BMP NUMBER: **99102**

COPY- FORD'S COLONY
SECTION 3B, S-61-96
(PC 148)

CODE COMPLIANCE REVIEW COMMENTS
FORDS COLONY SECTION 3-B DEL
PLAN NO. S-61-96
September 30, 1996

CODE COMPLIANCE REVIEW COMMENTS
FORDS COLONY SECTION 3-B
PLAN NO. S-61-96
August 23, 1996 DEC

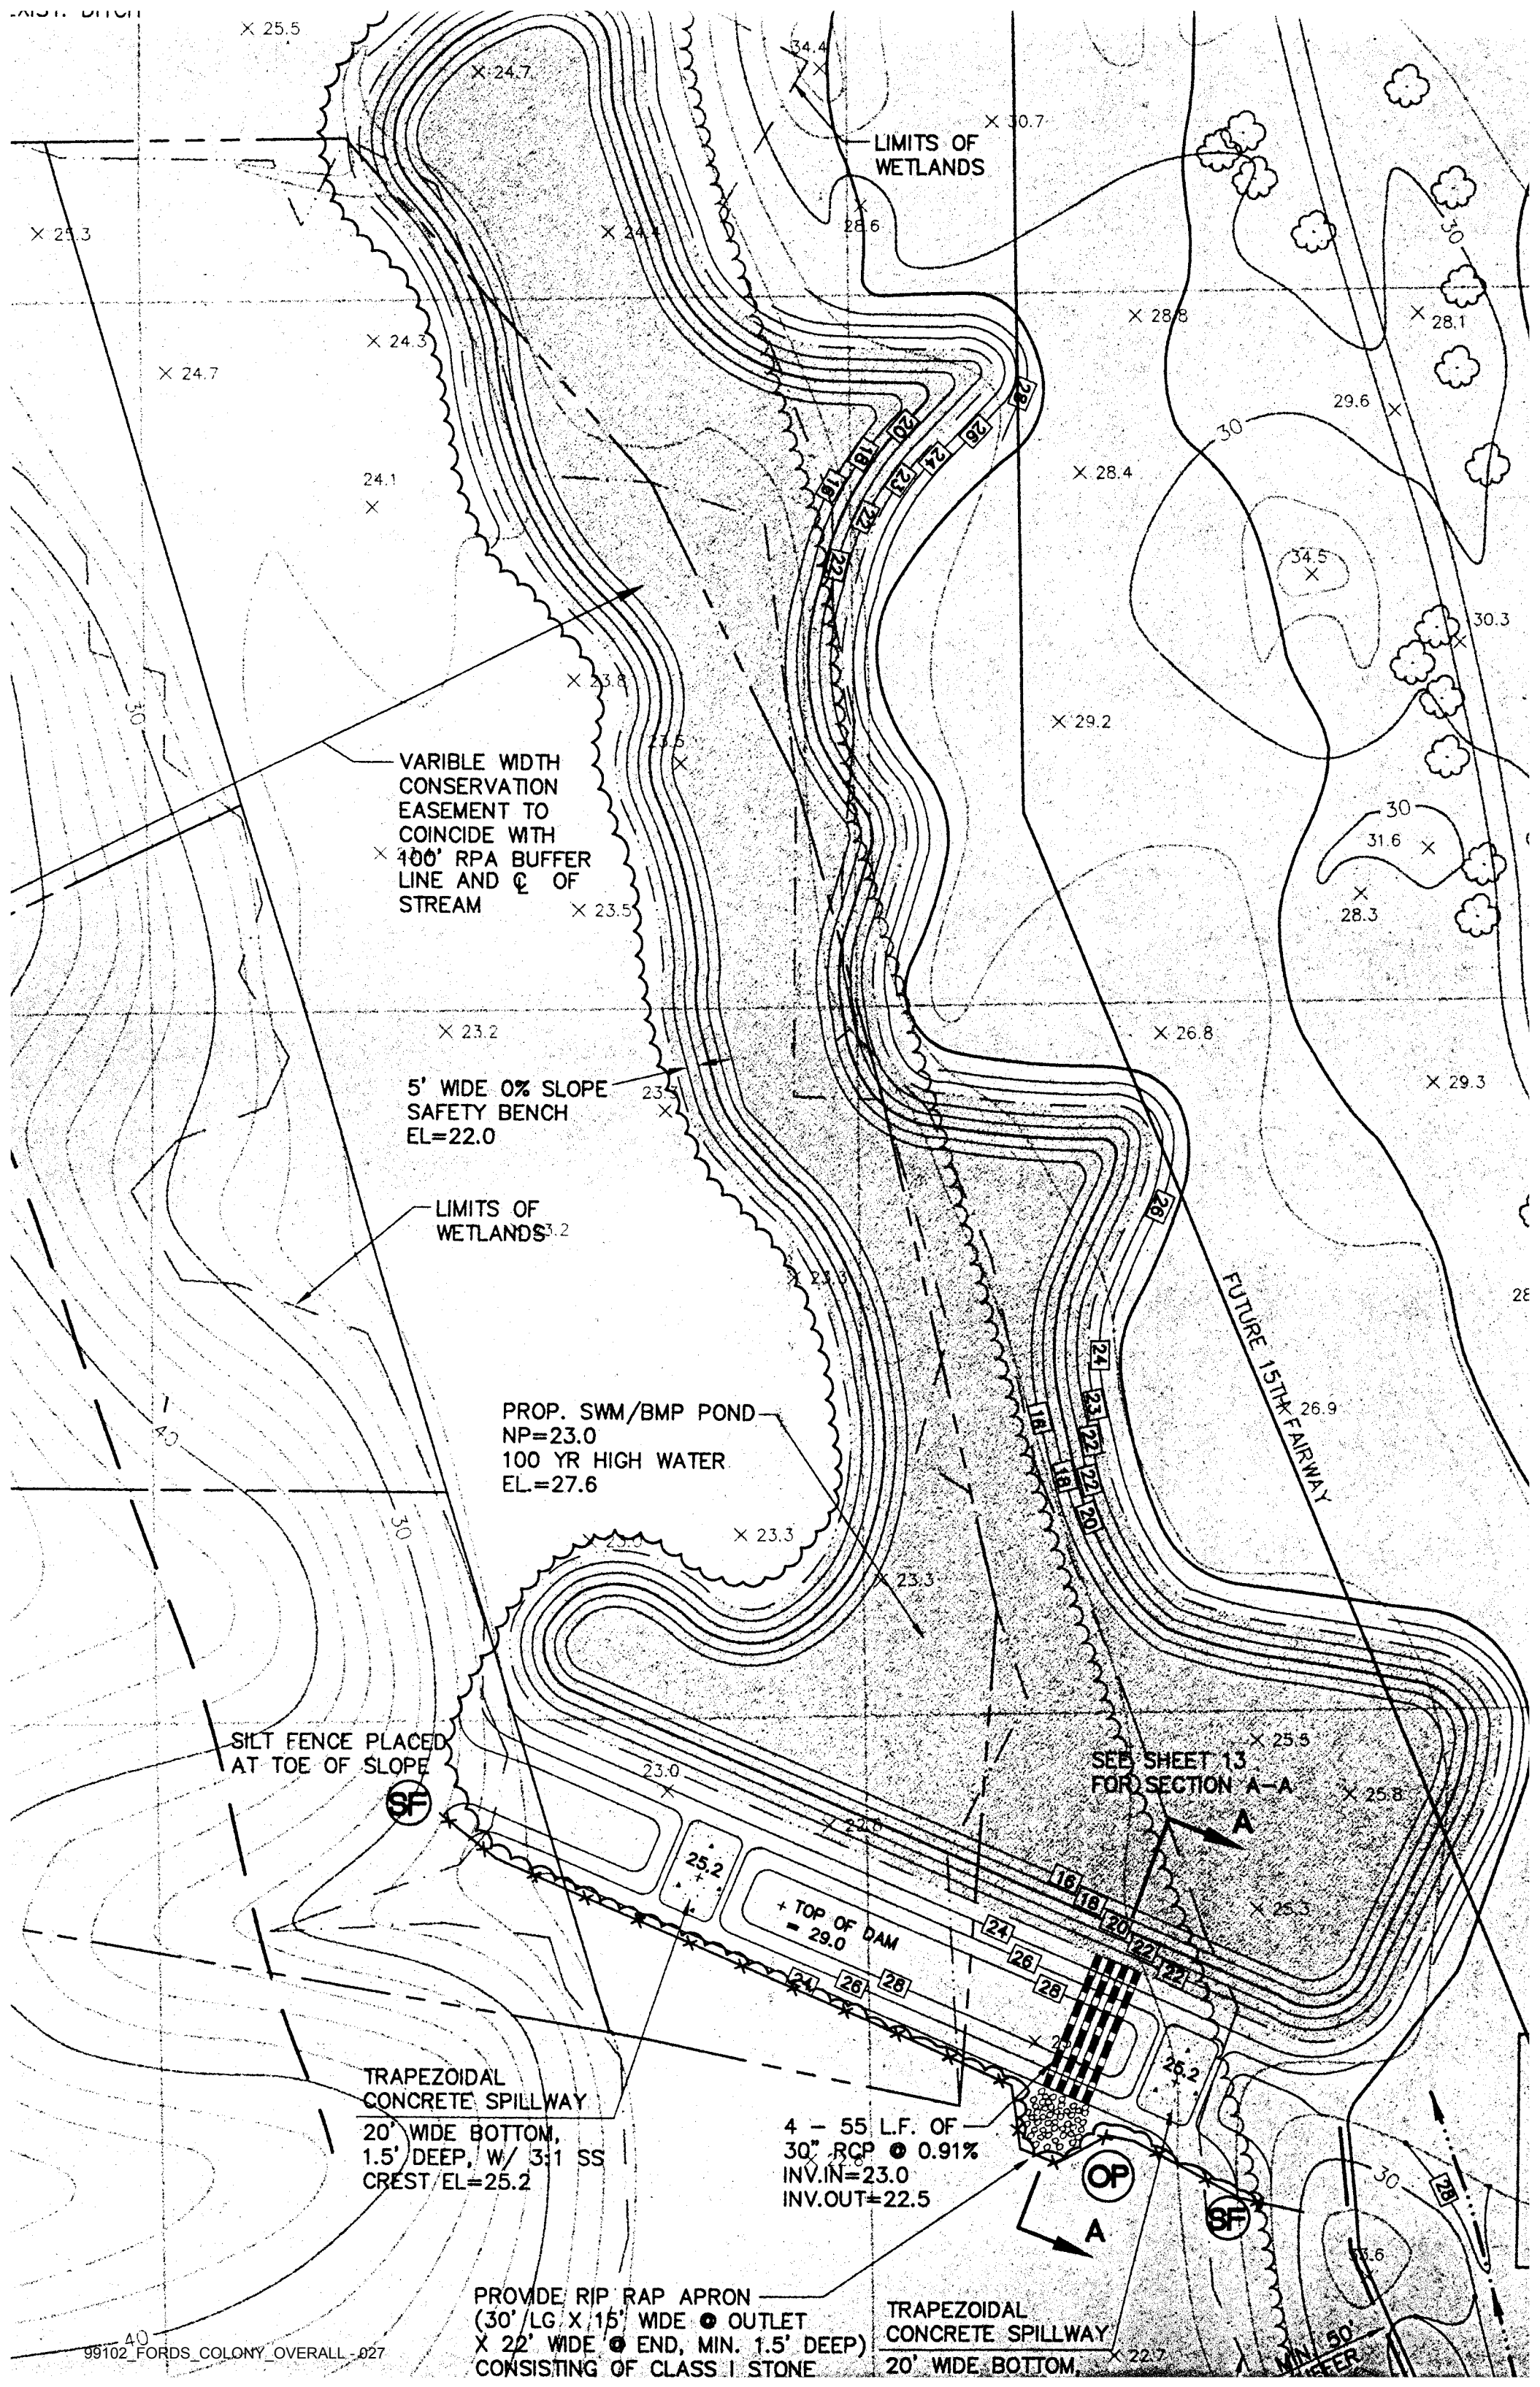
NA 4. The master stormwater management plan for Ford's Colony shows that the BMP proposed for this site only achieves 0.07 additional BMP points while the overall site achieves 10.28 points. Considering stormwater quantity, the BMP only reduces the 2-year storm from 85 cfs to 70 cfs. Finally, the BMP is located in an RPA and would impact a large area of wetlands. Given the small potential benefits of the BMP, the BMP shall be eliminated as the overall Fords Colony project can still achieve the 10 point criteria

12. The master stormwater management plan for Ford's Colony shows that the BMP proposed for this site only achieves 0.07 additional BMP points while the overall site achieves 10.28 points. Considering stormwater quantity, the BMP only reduces the 2-year storm from 85 cfs to 70 cfs. Finally, the BMP is located in an RPA and would impact a large area of wetlands. Given the small potential benefits of the BMP, the BMP shall be eliminated as the overall Fords Colony project can still achieve the 10 point criteria

12. The proposed SWM/BMP pond has been approved as part of the Ford's Colony Master BMP Plan. AES and Ford's Colony consider the pond to be an integral part of the Ford's Colony land plan and ,therefore, do not wish to delete the pond from the plans for this subdivision. A meeting between AES, Ford's Colony, and Bernard Farmer of JCC Code Compliance on this issue is forthcoming.
